Stage 1 Road Safety Audit

Designer's Response

Roundstone Lane, Angmering

Roundstone Lane, Angmering
Designer's Response to Stage 1 Road Safety Audit

Key Plan

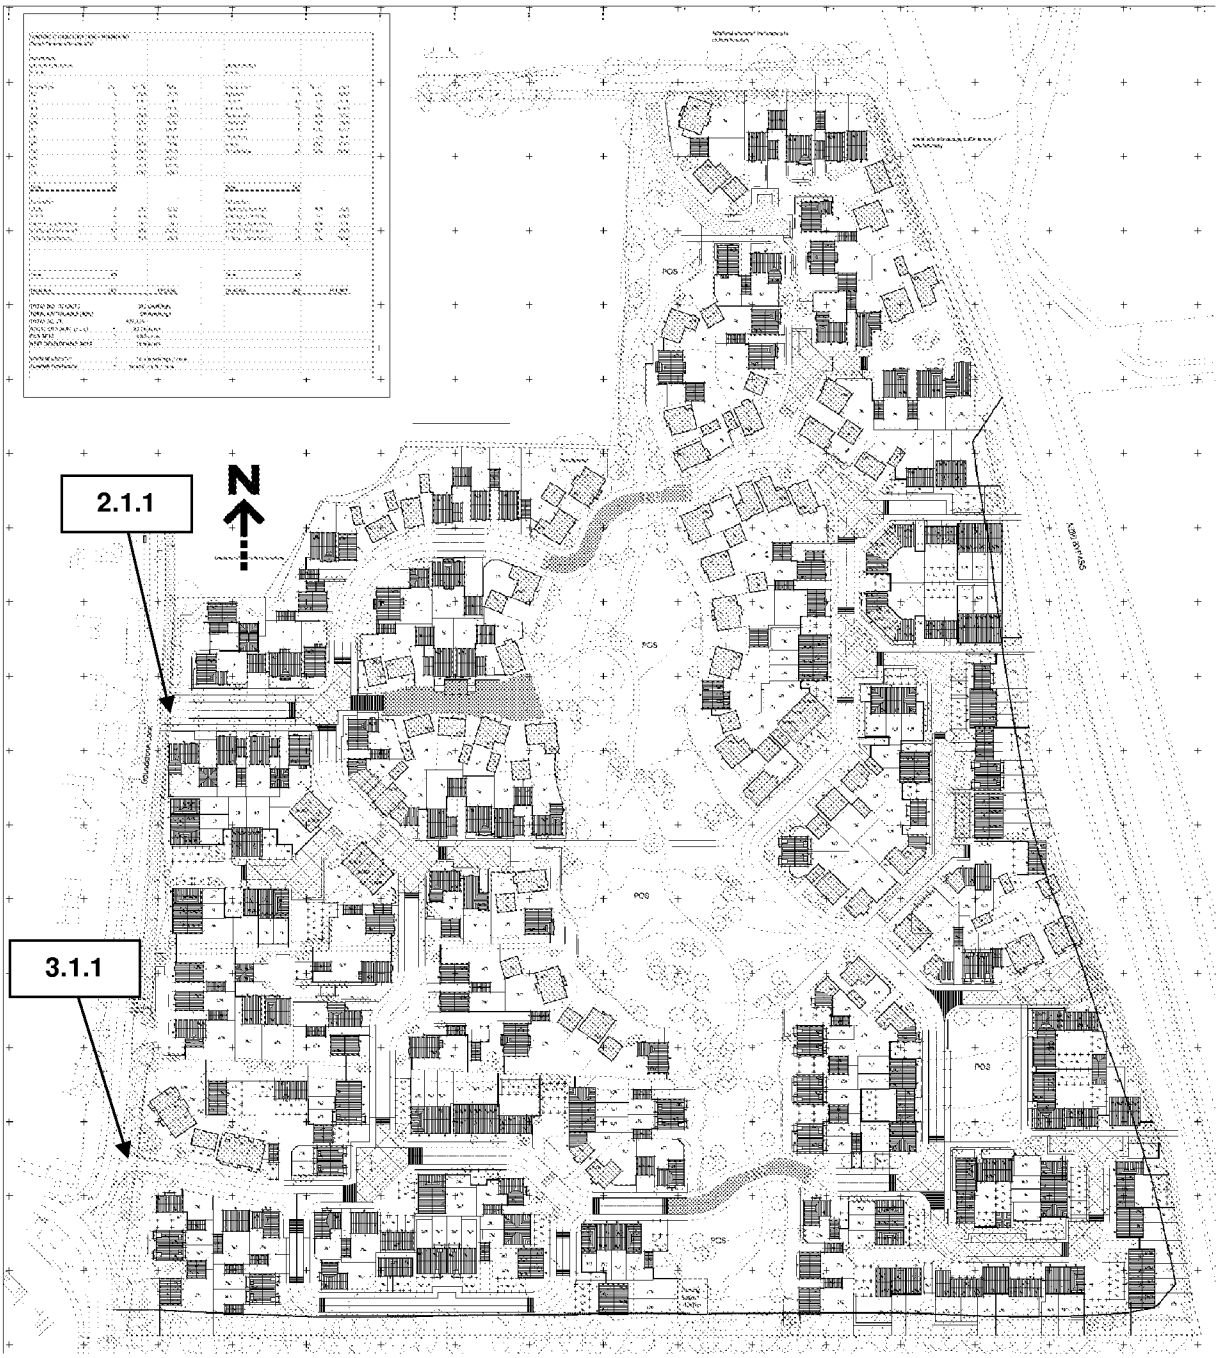
2.1.1 Location: New Access on Roundstone Lane – Location 3

Summary: Presence of build-out opposite proposed access could increase risk of the priority system being violated and potential collisions

The proposed access at Location 3 on Roundstone Lane will be directly opposite a build-out which forms part of a priority system. Once the access is constructed there is a risk that drivers will attempt to use the bell-mouth to pass each other and ignore the priority system. This could lead to vehicles conflicting with those approaching the junction on the new access road.

Remove the build-out.

3.1.1 Location: New Access on Roundstone Lane – Location 1

Summary: Visibility to the south is restricted by alignment/buildings increasing the risk of collisions

The proposed access is located approximately 25 metres from the junction of Nursery Road. The alignment and the nearby buildings restrict the visibility for drivers emerging from this access which could increase the risk of collisions with vehicles turning into Roundstone Lane from Nursery Road. This problem may be exacerbated by the speeds at which vehicles enter Roundstone Lane which was noted as being high at the time of the site visit.

Move the access further North on Roundstone Lane and ensure sufficient visibility is provided.

Safety Audit Comment	Recommendation	Designer's Response
2 General		
2.1 Access		
2.1.1 Location: New Access on Roundstone Lane – Location 3 Summary: Presence of build-out opposite proposed access could increase risk of the priority system being violated and potential collisions The proposed access at Location 3 on Roundstone Lane will be directly opposite a build-out which forms part of a priority system. Once the access is constructed there is a risk that drivers will attempt to use the bell-mouth to pass each other and ignore the priority system. This could lead to vehicles conflicting with those approaching the junction on the new access road.	Remove the build-out.	We propose to remove the build-out and construct a raised table in place to form the priority junction as shown on drawing 104A attached.

Safety Audit Comment	Recommendation	Designer's Response
3 Junctions		
3.1 Visibility		
3.1.1 Location: New Access on Roundstone Lane – Location 1 Summary: Visibility to the south is restricted by alignment/buildings increasing the risk of collisions The proposed access is located approximately 25 metres from the junction of Nursery Road. The alignment and the nearby buildings restrict the visibility for drivers emerging from this access which could increase the risk of collisions with vehicles turning into Roundstone Lane from Nursery Road. This problem may be exacerbated by the speeds at which vehicles enter Roundstone Lane which was noted as being high at the time of the site visit.	Move the access further North on Roundstone Lane and ensure sufficient visibility is provided.	This junction will no longer be used to serve the development which has been reduced in scale and no longer requires this access.
